Reference: Peer Review for Preliminary Stormwater Management Report & Jack Creek Floodline Commentary
Pilgrim's Rest Part lots 3 & 4, Concession 11 (Burleigh) Township of North Kawartha, County of Peterborough

Reference: Peer Review: Tranplan Associates, Pilgrim's Rest Campground Fire Route 24 Access Traffic Impact Statement

**Reference: Hydrogeological and Site Servicing Study
Proposed Residential Development, Pilgrim's Rest Campground
Part Lots 3 & 4, Concession 11, Township of North Kawartha**

Reference: Peer Review of Environmental Impact Study for a Proposed Residential Redevelopment of Pilgrim's Rest Campground (March 2016), prepared by Oakridge Environmental Ltd.

Exhibit 2 Concept Plan

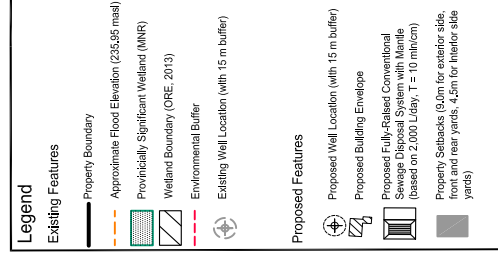
- **Section 2.2:** The report mentions that 90 - 92 metres of sight distance is currently available towards the left of the Fire Route 24 entrance onto Cheboutequion Drive. As per *Figure E3-6* of the MTO *GDSOH*, the minimum stopping sight distance for a design speed of 60 km/h is 85 metres. Based on our assessment, the available sight distance from the Fire Route 24 driveway looking towards the left is approximately 70 metres. As a result, the minimum stopping sight distance would not be sufficient. The correct available sight distance should be reviewed carefully to ensure that vehicles exiting the driveway are not subject to unsafe conditions.

- **Section 3.0:** We do not agree with the conclusion that the intersection of Cheboutequion Drive with Fire Route 24 has sufficient turning sight distance, as discussed above. Drivers exiting Fire Route 24 are not expected to have difficulty finding adequate gaps on Cheboutequion Drive due to the low volumes along Cheboutequion Drive, however, the low visibility to the left of Fire Route 24 may result in unsafe conditions by not providing drivers with enough sight distance to anticipate when it is safe to exit.
